Appendix L

# Response to Comments

In October, 2013, DNR released the Revised Draft Environmental Impact Statement (RDEIS) for the Olympic Experimental State Forest (OESF) forest land plan. Due to the interest shown by stakeholders and the public, DNR held an extended comment period (45 days instead of the required 30 days) for the RDEIS. During the extended comment period, DNR received comments from a wide range of individuals and organizations (Table L-1).

**Figure 2.** Comparison of average annual precipitation and average bankfull width.

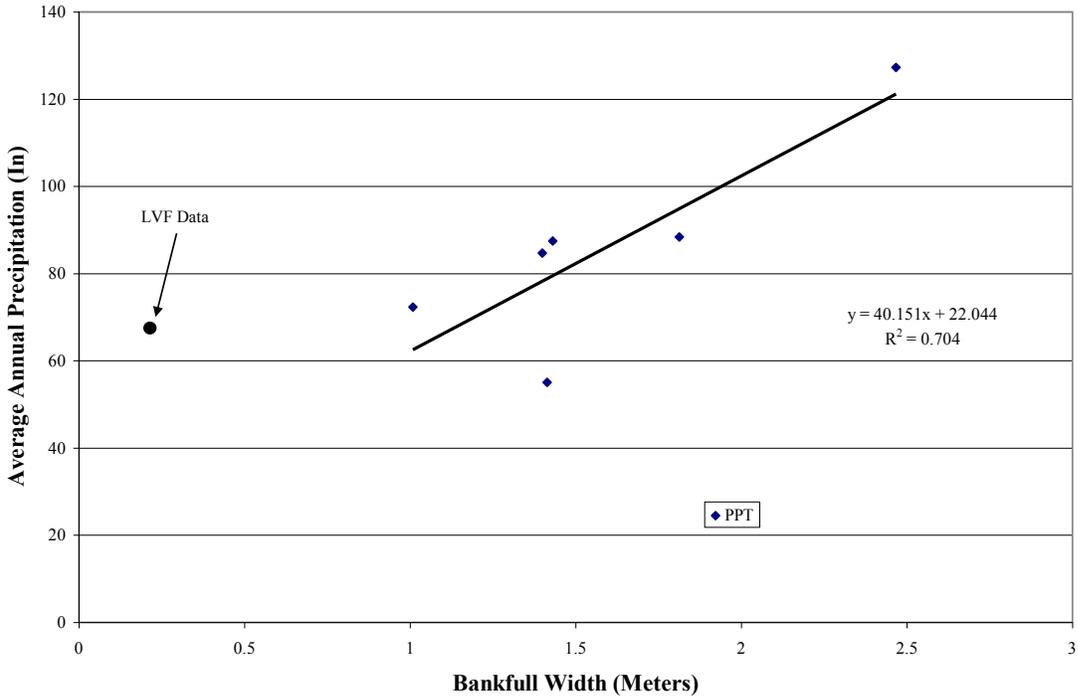
Stream reaches less than 2 ft wide made up 18.9 percent of the stream length surveyed (including LVF data). However, within the LVF dataset streams less than 2 ft wide composed 96-percent of the stream length surveyed, providing further evidence that these data are outliers from the rest of the PIP survey data. **Figure 3** depicts the percent of stream length surveyed less than two feet wide by PIP study cooperator. It is important to note that PIP data collected by Skagit System Cooperative (SSC) were collected from the channel head downstream until 200 meters of continuous flow were recorded, therefore these data do not include the total length of the Type 4 stream network within the headwater channel. Most other datasets were collected from the confluence with a Type 1-3 stream, upstream to the channel head.

**Figure 4.** Percent of streams surveyed classified by length (meters) of Type 5 water.

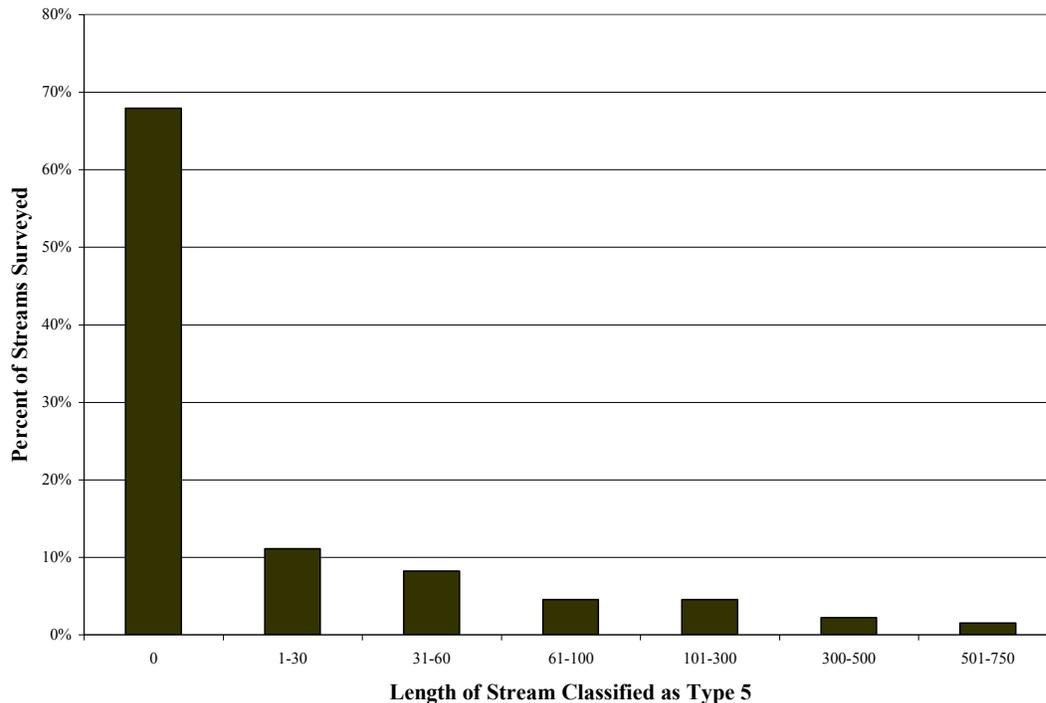
The Longview Fiber (LVF) dataset was not included in the final analysis due to suspect width measurements (see above). A total of 36,367 meters of PIP survey data collected in 134 survey reaches indicates that Type 5 streams comprised 12.5 percent of the channel network surveyed. Of the 134 streams surveyed 91 (68%) surveys contained no Type 5 water. Less than 10 percent of streams surveyed contained greater than 100 meters of Type 5 water. Less than 4 percent of the streams surveyed contained greater than 300 meters of Type 5 water (See **Figure 4**).

**Figure 5.** Comparison between WDNR RDEIS and Middle Coast-Landscape Plan Kalaloch Planning Unit Channel Assessment Module bankfull width to contributing basin area models (source: WDNR 2013; Haggerty 2004a).

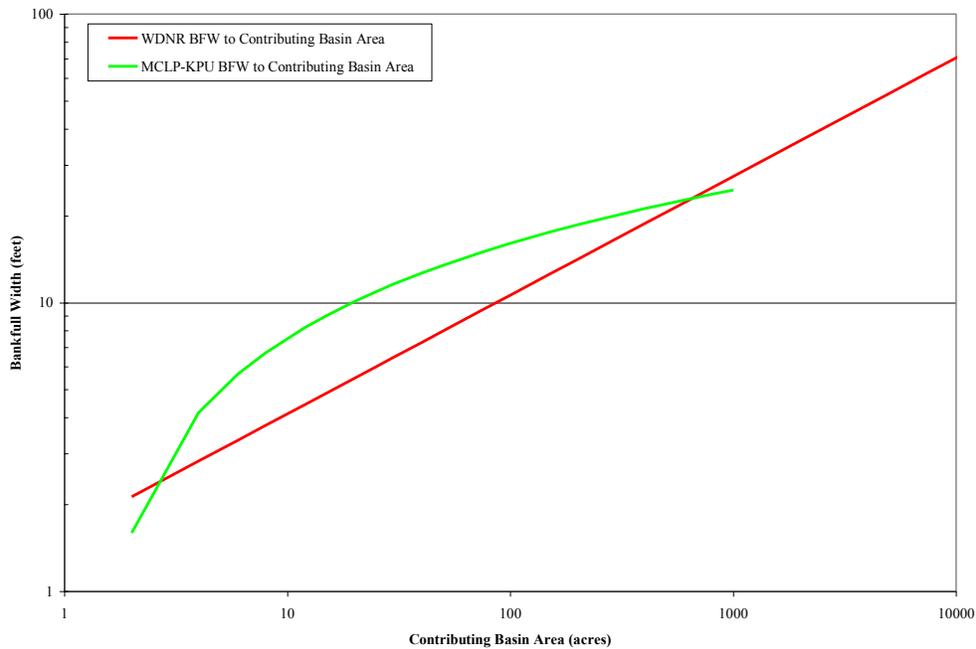
The model DNR uses to calculate shade in Appendix G (Equation G-22) projects that stream width is greater than 2 feet once the contributing drainage basin approaches two acres (**Figure 5**). This fact suggests that that most streams mapped as Type 5 streams are actually Type 4 streams. Included below in **Figure 6** is an example of modeling conflicts taken from the Clallam Landscape in WRIA 19.0143 (locally referred to as Falls Creek). In the example there is a Type 5 stream with a basin area of 125 acres. One model (Equation G-22) assumes the channel is 11.6 feet wide at the confluence with the stream to the north, while the water type map estimates the channel is less than 2 feet wide (Type 5). Yet another model (FP Fish Habitat) estimates 1,000 feet of the Type 5 water is fish bearing. The contributing basin upstream of the modeled Fish/No Fish break is 74 acres. Here Equation G-22 estimates the channel to 9.4 feet wide, but the water type map estimates the channel to be less than 2 feet wide (Type 5). A third model estimates 1,500 feet of "essential coho summer rearing habitat" are included in this subbasin which is located upstream of a known and mapped anadromous fish barrier. This example is not an isolated problem. A quick comparison of stream type attributes and basin areas suggest this issue is wide spread throughout the OESF.

**Figure 10.** Comparison between DNR channel width measurement and OHW width in a Type 3 stream (based on physical habitat) classified as a Type 5 stream by DNR.

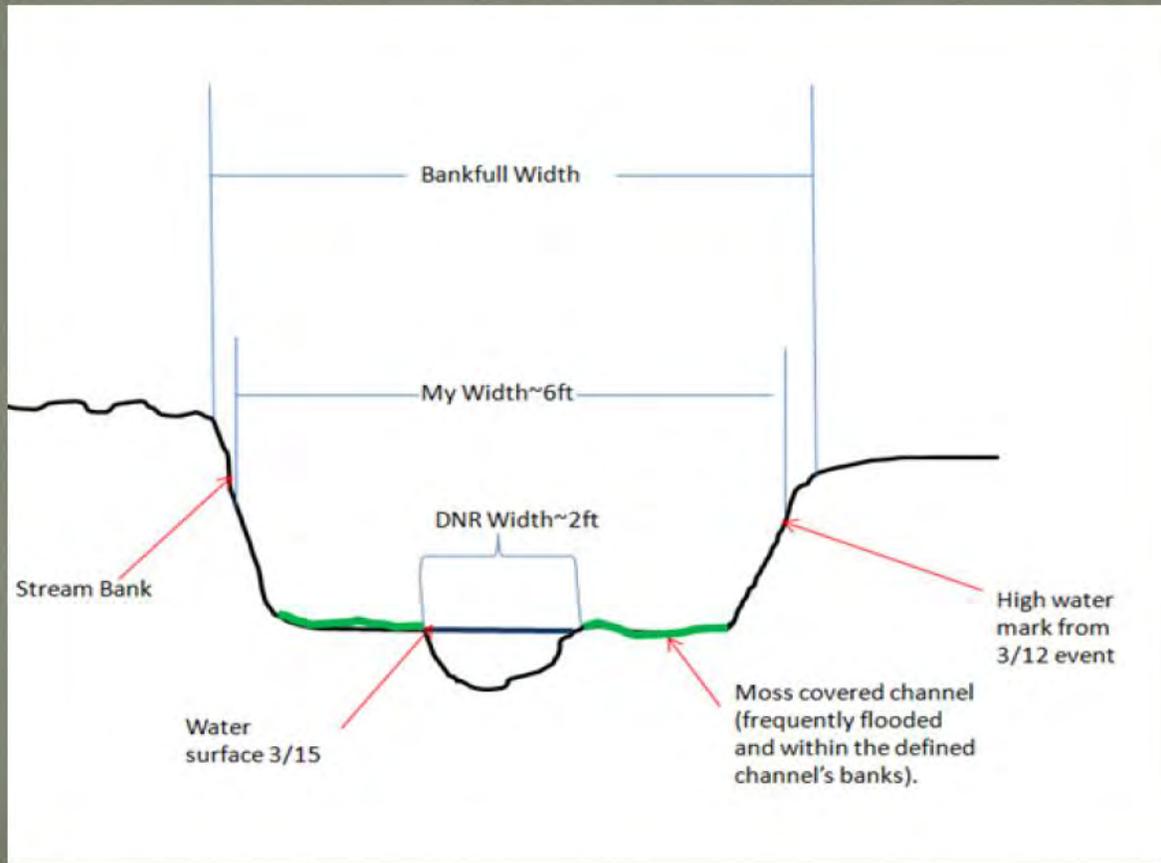
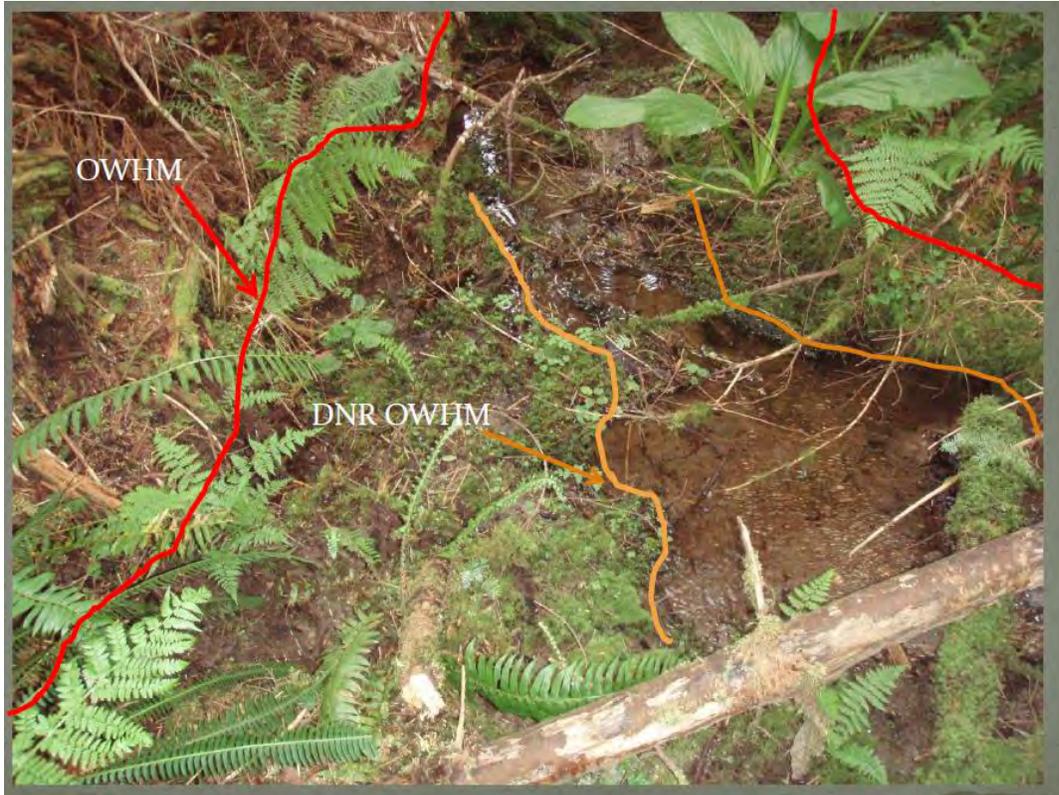
Furthermore, DNR's ability to measure OHW width in the field is questionable. This results in frequent under-typing of stream channels. Included below are some examples from recent stream typing conducted by DNR followed up by a field review that I conducted (see **Figure 7** through **Figure 10**).

The stream in **Figure 10** was typed by DNR as a Type 5 stream, their average width measurements were 1.8 ft. However, a 750 ft reach had an average width 2 feet or greater based on their measurements! This stream meets the definition of Type 3 water. What is most alarming is that DNR's measurements over represent the narrowest portions of the channel. DNR's average channel width is less than 23% of the average OHW width I measured following strict protocols. DNR's width measurements underestimated OHW width, scoured width, and wetted widths at average winter-time discharges. We did a detailed follow up analysis on this stream reach. We collected measurements at 5 foot intervals: we measured only the wetted width within the scoured, vegetation free portion of the channel at streamflows significantly less than an ordinary high water event. The results are included below in **Figure 11**. The results strongly suggest that DNR staff need training in stream typing and the identification of OHW width.

**Figure 11.** Comparison between DNR channel width measurements and OFCO wetted width measurements taken at 5 foot intervals within only the scoured, vegetation free portion of the channel at flows significantly less than an ordinary high water event.

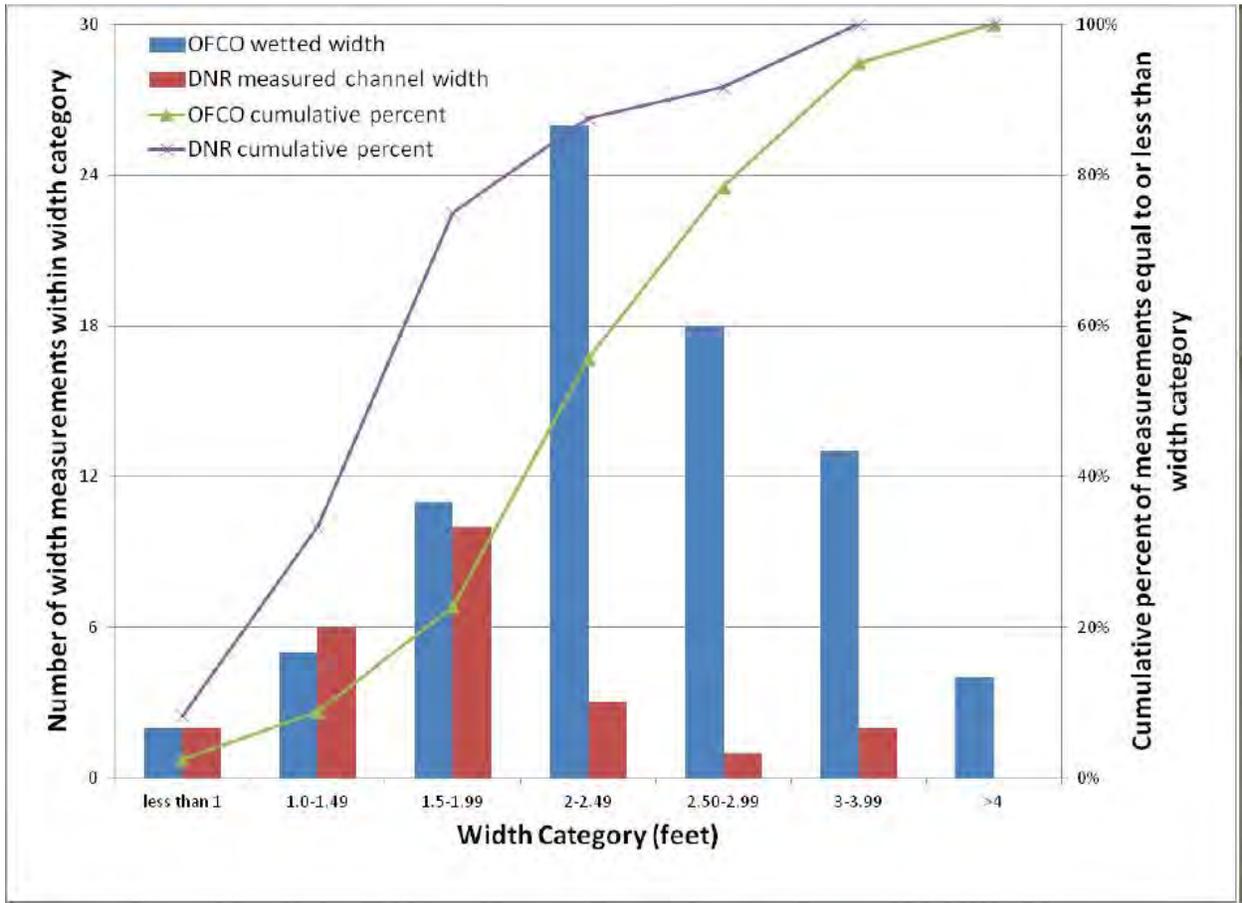
The mistyping of streams can and has had significant adverse impacts. One recent example in the OESF was associated with the mistyping of a stream in Clallam Combined FPA (Unit 4) and Stumpy's Ride (Unit 5). The Clallam Combined FPA did not map the stream at all. The Stumpy's Ride FPA mapped the stream as a Type 5 (labeled stream 5x) up to the edge of the harvest unit. When right-of-way timber harvest was conducted for the Clallam Combined FPA Unit 4 road conditions were highly degraded and sediment and sediment laden waters were routed into this stream. At the downstream end of the road crossing turbidity readings averaged

**Figure 12.** Comparison of percent timber harvested by harvest category divided by percent of forested area within the OESF.

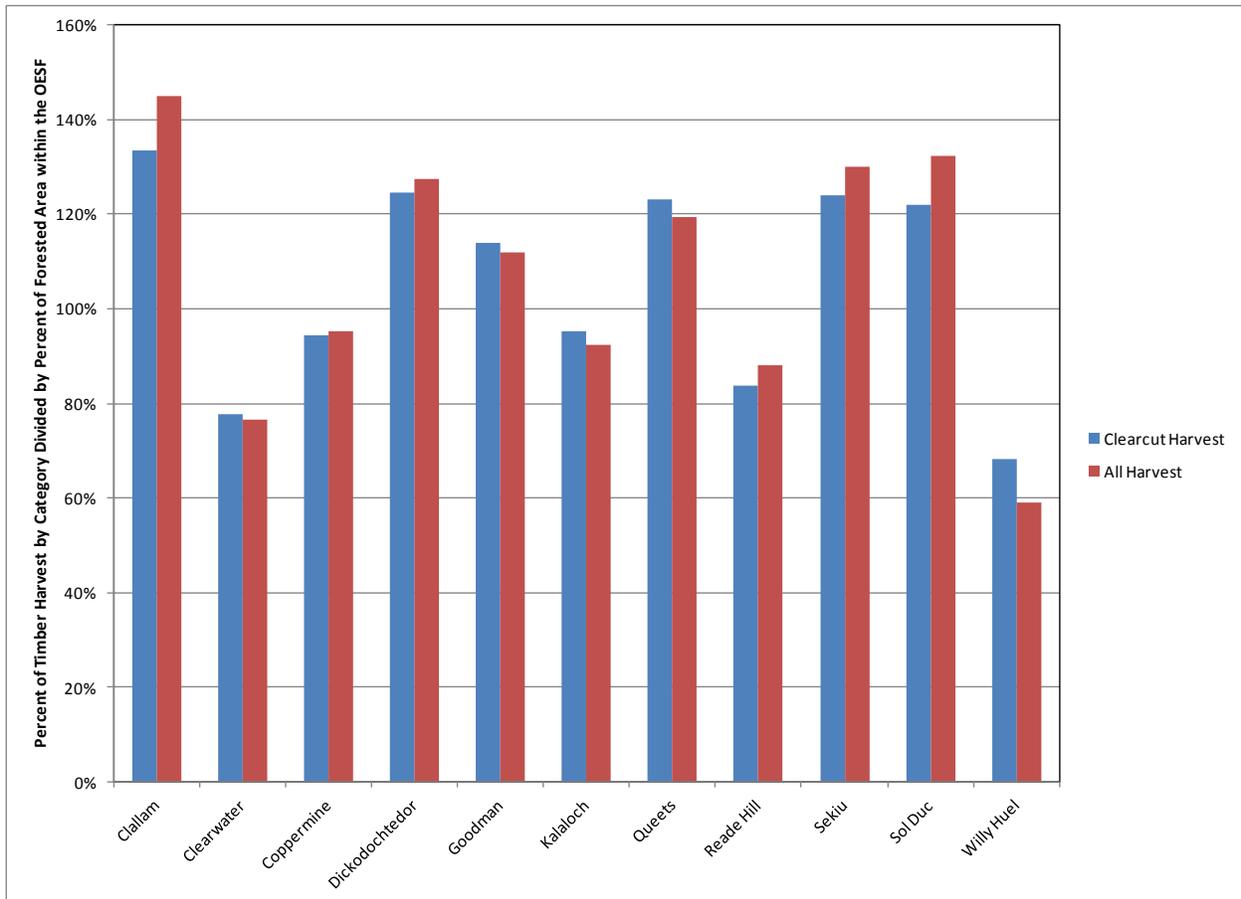
The Clallam Landscape under the Landscape Alternative is considered to have high potential impacts. That is, more than 20% of the area is rated as having potential high impacts. It seems

unlikely that this complies with the intent of the HCP. There are likely multiple reasons for this (e.g. accelerated harvest of older forest, reduced riparian buffers, etc...). If you look at the proportion of the "forested" landscape you will see that the Clallam Landscape represents 6.7% of the OESF. The total percent of variable retention harvest in the OESF that is proposed to come from the Clallam is 8.9% and combined variable retention and thinning percent is 9.7%. This harvest is 33% and 45% greater than the percent of the forested landscape contained within the OESF. The Clallam has the highest rate of timber harvest of all LPUs (see **Figure 12**).

**Figure 13.** Analysis area acres clearcut by age category within the early and recent HCP implementation period.

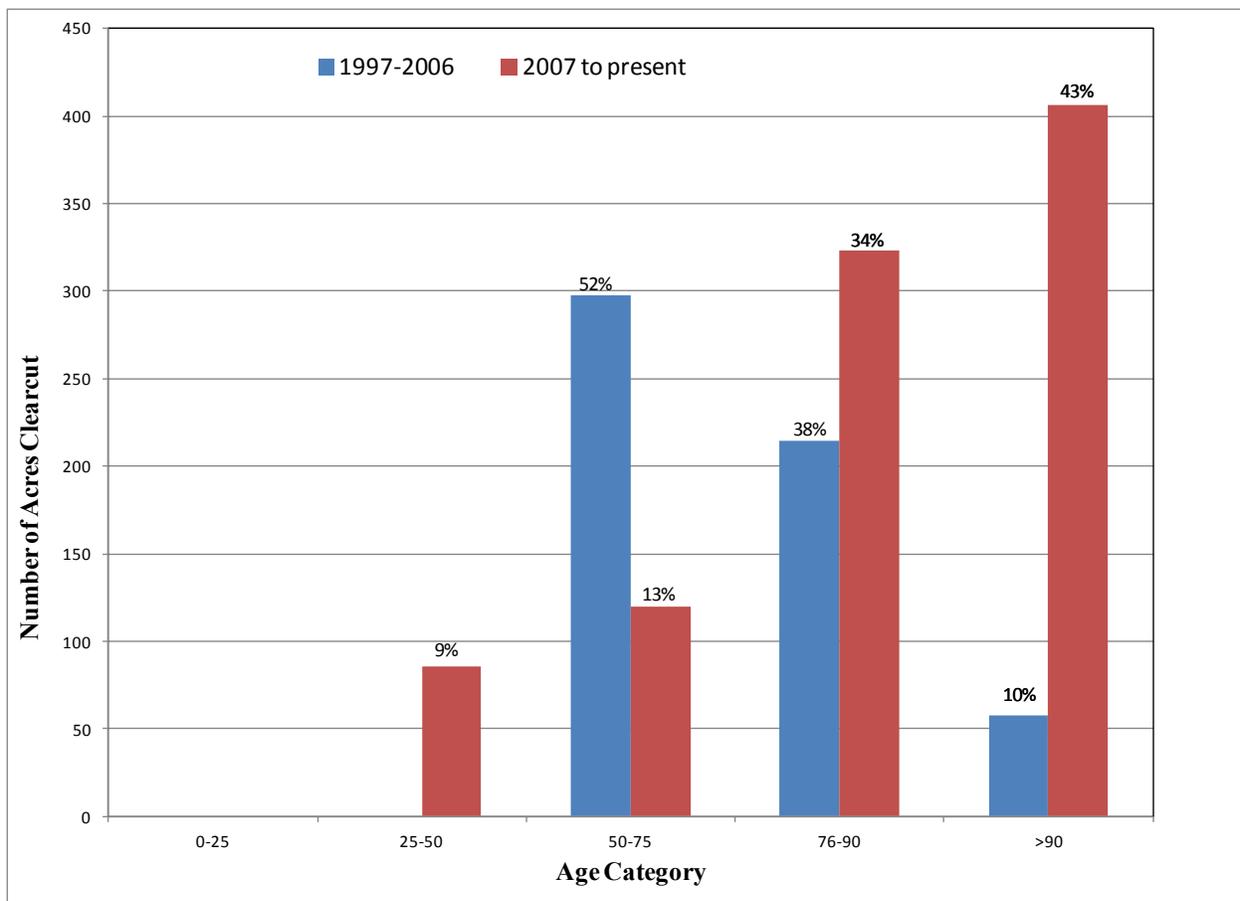
Two periods were evaluated- early implementation (1997-2006) and recent implementation (2007 to present). During the early period a total of 613 acres were clearcut in the analysis area (61 acres per year). Stand ages were known or estimated for 570 acres. No inventory data were available for 43 acres. During the early period 10% of harvest was in stands greater than 90 years old and 38% was in stands 76-90 years old. The remaining 52% of harvest was in stands 50-75 years old. During the recent period a total of 946 acres were harvested or are in the process of being harvested. The proportion of harvested stands over 90 years old significantly increased during the recent implementation period. The proportion of stands greater than 90 years old that were clearcut went from 10% to 43%. Many of these stands may have been structural habitat but were not mapped as such. At least one stand that is being clearcut is mapped as Old Forest in the proposed mapping used in RDEIS. **Figure 13** depicts the acres clearcut in each time period, for each age category. The point is that recent harvest of older stands, the more intensive harvest proposed for the future, and reduced buffer widths have delayed the time to reach 20% old forest conditions and are in part responsible for the high impact rating for the Clallam Landscape.

**Figure 14.** Comparison of LWD recruitment potential based on RDEIS model and varying site potential tree heights.

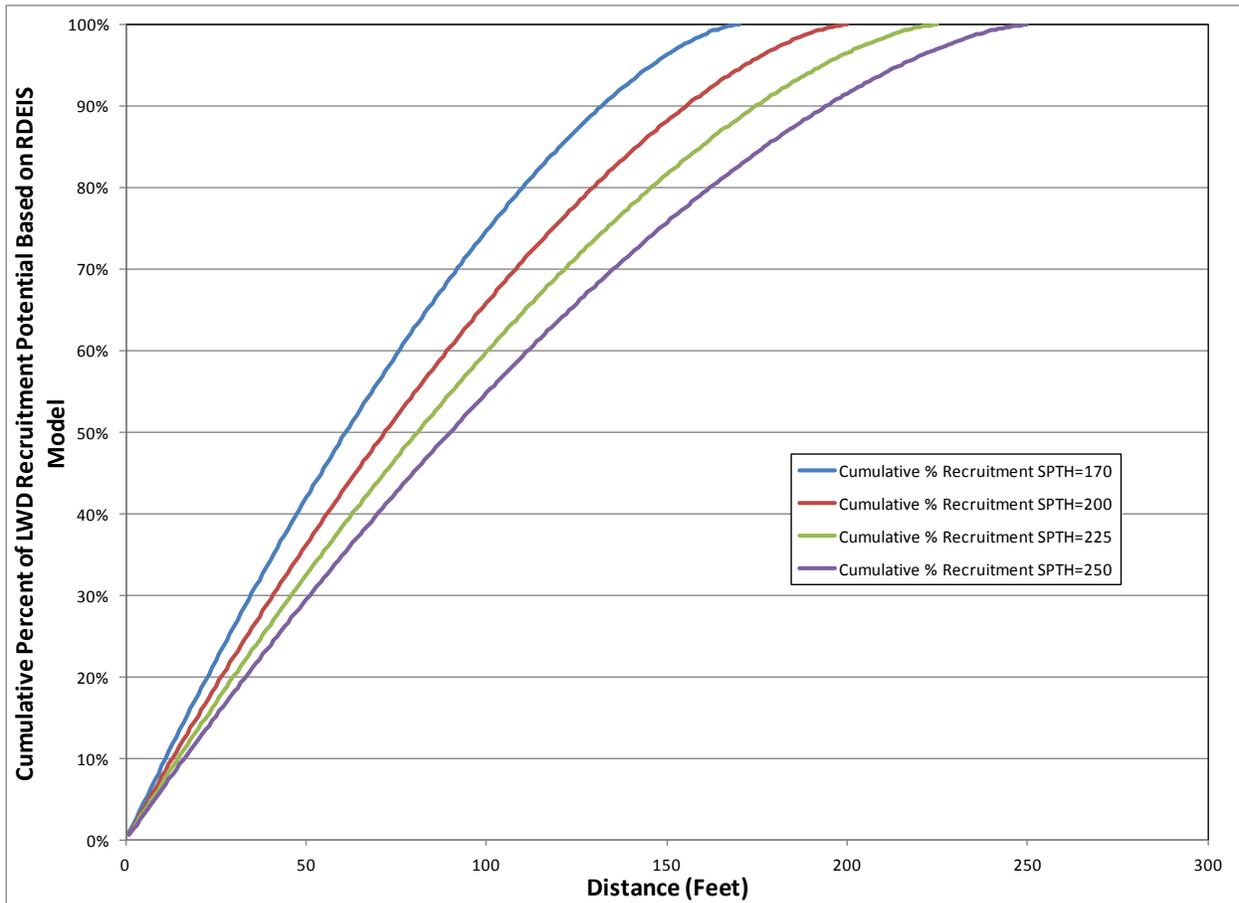
The RDEIS states, "*For this analysis, a site potential tree height was defined as 170 feet.*" The rationale for providing this distance is the average distance used by FEMAT who defined the SPTH as the average maximum height of the tallest dominant trees (200 years or more in age). The RDEIS then continues by stating that for Type 1 and 2 streams the average SPTH at age 120

is 168 ft and for Type 3-5s the average is 165 ft. This seems to contradict the 170 ft SPTH used in the analysis. Is it assumed that the trees only grow 2 to 5 feet during the next 80 years of growth? The choice of the SPTH used to evaluate LWD recruitment potential makes a big difference in the percentages of potential recruited LWD by zone analyzed in the RDEIS (See **Figure 14**). For example, within the zone from 0-100 feet the 170 ft SPTH is projected to contribute just less than 75% of the LWD. For a SPTH of 225 feet less than 60% of the LWD is projected to come from the 0-100 ft zone. I could find little data on SPTHs at age 200 for the OESF. The North Fork Calawah Watershed Analysis Vegetation Module (Farrell 1999) states that SPTHs for riparian reserves for the majority of streams in the North Fork Calawah Watershed will range from 170 ft to 229 ft, with SPTHs of 211 feet being very common.
